NOTICE OF A TYPE I DECISION ON A PROPOSAL IN YOUR NEIGHBORHOOD

CASE FILE NUMBER: LU 08-125124 LDP

PRELIMINARY PLAT
3 LOT PARTITION
FOR
3817-3827 NE MLK Blvd.
PORTLAND, OREGON

CASE NO. LU 08-125124-00P
 EXHIBIT C.3

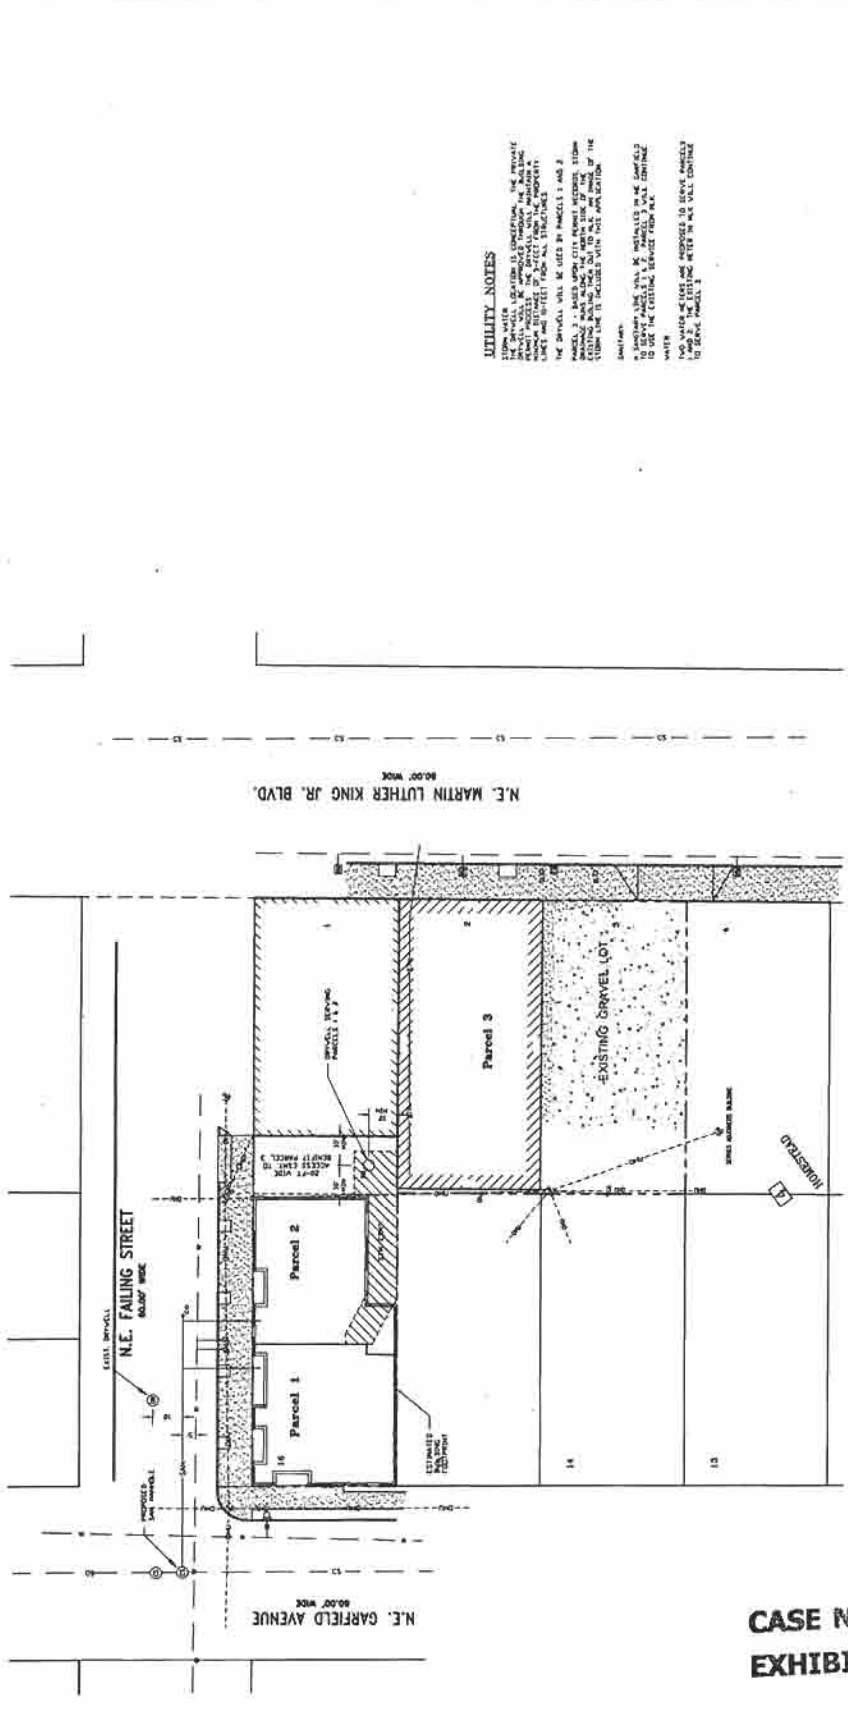
The applicant has proposed the following stormwater management methods (Exhibit C.3), and the Bureaus have responded as follows (Exhibits E-1 and E-5):

- Parcels 1 and 2:** Stormwater from these lots will be directed to a shared drywell located on Parcel 2 in the 20-foot wide access easement to Parcel 3. The drywell will treat the water and slowly infiltrate it into the ground. Parcel 2 has sufficient area for a stormwater facility that can be adequately sized and located to meet setback standards, and accommodate water from reasonably-sized development on each parcel. Site Development has indicated conceptual approval of the drywell. However, the applicant is proposing 100 percent building coverage on Parcel 1. This will require that the rain drain serving the building on Parcel 1 to be built under or through the future building on Parcel 2 to dispose of the stormwater in the shared drywell. Approval of a plumbing code appeal (Exhibit A.5) has been granted to allow the proposed rain drain to be built through the building to be built on Parcel 2 through a private stormwater easement.

- Parcel 3 (the parcel with existing commercial development):** The existing building has downspouts that drain into the public sewer in NE MLK Blvd. Site Development has noted that the downspout for the existing building is in disrepair and not connected to the existing rain drain system, and therefore must be repaired to meet City standards prior to final plat approval to ensure that the stormwater from the existing building can get to the disposal point. The applicant is required to finalize plumbing permits prior to final plat approval for modifications to the stormwater disposal system on the existing house that will result in properly functioning gutters, downspouts, and disposal points.

1. The applicant shall meet the requirements of the Bureau of Environmental Services (BES) for extending a public sewer main in the NE Failing Street. The public sewer extension requires a Public Works Permit, which must be initiated prior to final plat approval. In addition, the applicant must provide engineered designs, and performance guarantees for the sewer extension to BES prior to final plat approval.

2. The applicant must meet the requirements of Site Development to reconnect the downspout on the west side of the existing building at 3827 NE MLK Blvd.
3. The applicant must plant street trees in the planter strip on NE Failing Street and NE Garfield Street adjacent to Parcels 1 and 2. Street trees will be chosen from the City's approved street tree list for the five and four foot planting strip respectively. The applicant must contact Urban Forestry at 503-823-4018 prior to selecting trees to discuss the species of trees that are permitted and to obtain the planting permit. Urban Forestry must inspect and approve the newly planted trees prior to final plat approval.

4. The Covenant for Future Storm Sewer Easement and Maintenance Agreement Effective Upon Date Sale (Exhibit A.6) approved as part of Plumbing Code Appeal 5661 shall be recorded with Multnomah County for the Private Stormwater Management Easement area described in Condition B.1 above.
5. A Maintenance Agreement shall be executed for the Access Easement area described in Condition B.2 above. The agreement shall include provisions assigning maintenance responsibilities for the easement area and any shared facilities within that area, consistent with the purpose of the easement, and all applicable City Code standards. The agreement must be reviewed by the City Attorney and the Bureau of Development Services, and approved as to form, prior to final plat approval.
